# SERVICE BULLETIN

Service Bulletin No.: DA20-77-01, Rev. 0

Date Issued: July 30, 1996

Title: Tachometer, Cable Assembly, Inspection.

FIGURE 1.

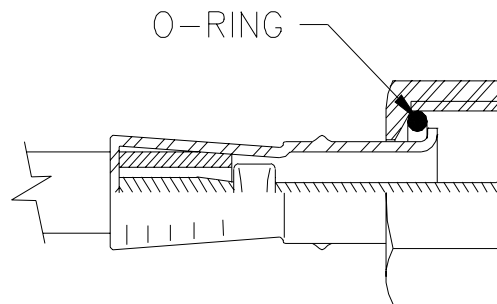
11.1.4 Ensure that the O-Ring is installed at the Engine end of the cable.

FIGURE 3.

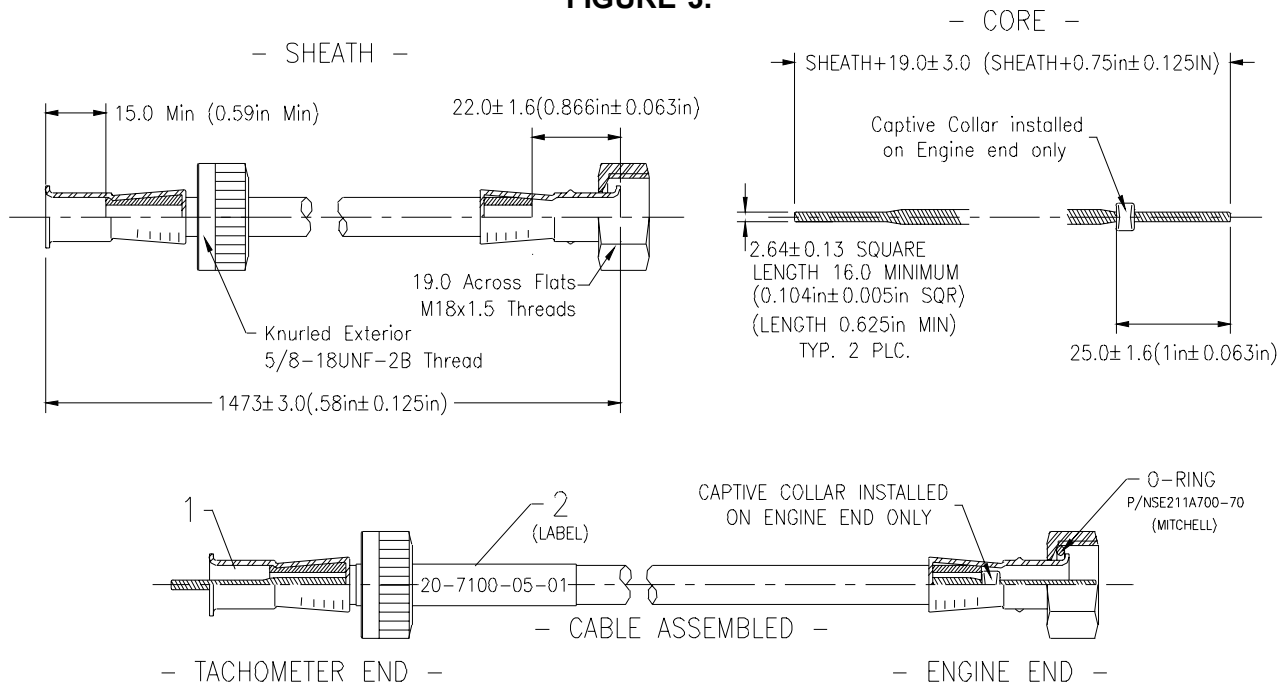
11.1.9 If the above items are O.K., install an identification sleeve at the instrument end of the Cable. (See Figure 3).

11.1.10 **If the cable does not meet the inspection requirements, then replace the entire Cable Assembly with part No. 20-7100-05-01.**
